PLAN COMMISSION MEETING AGENDA

MONDAY, DECEMBER 09, 2024 AT 4:30 PM

TO: Plan Commission
DATE: December 9th, 2024
SUBJECT: 700 Hoffman Dr, Conditional Use Permit - CUP

PROPOSED MULTI-FAMILY DEVELOPMENT
LUMIN TERRACE
JOHNSON STREET • WATERTOWN, WI

RE: Edge Field Preliminary CSM Review

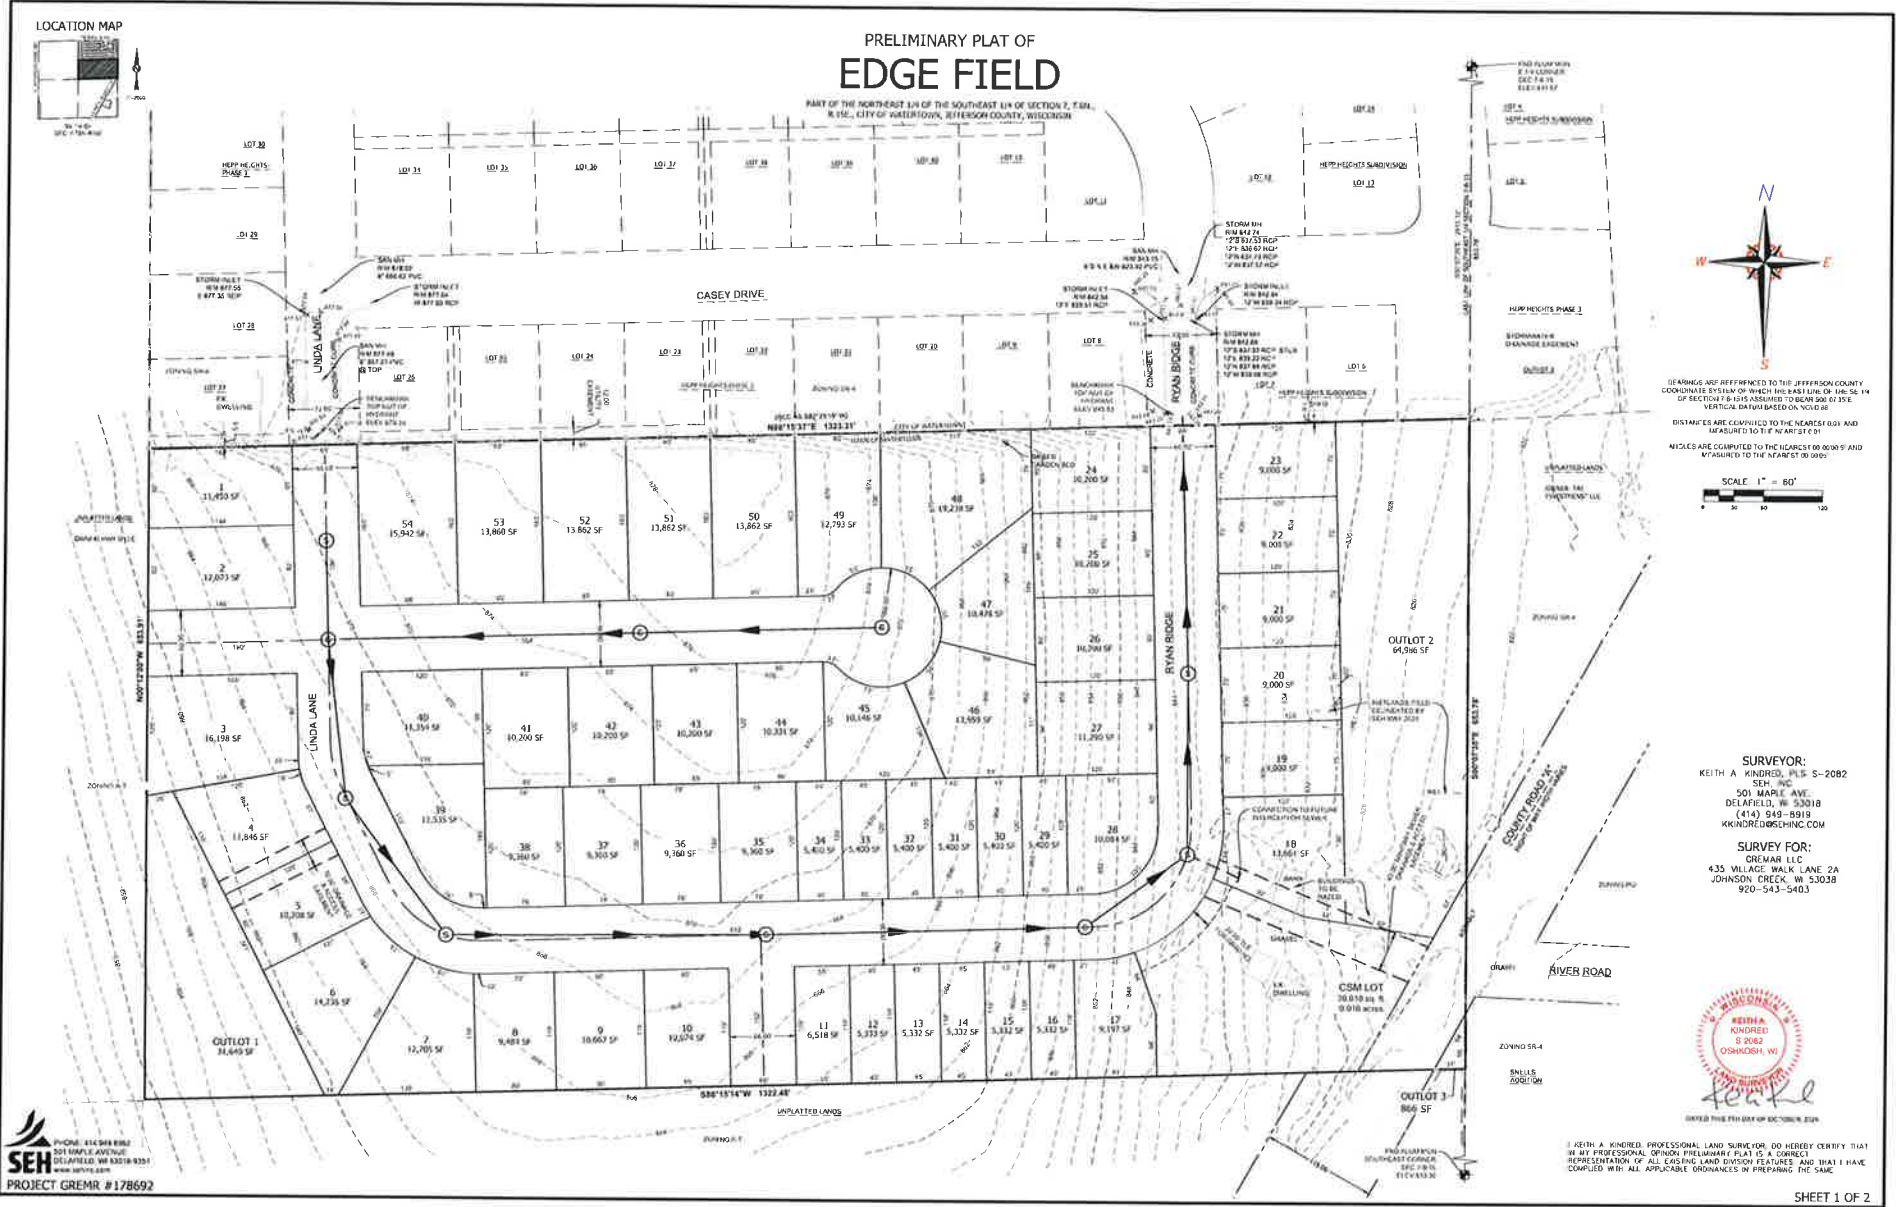
The County Surveyor and I have reviewed the preliminary CSM for Edge Field, prepared by Keith Kindred, PLS, job no. 178692, as dated October 15, 2024, and have the following comments:

- label the radii of the curves
- label the City/Town corporate limits
- Include a road name for the east/west cul-du-sac road and the southernmost road stub
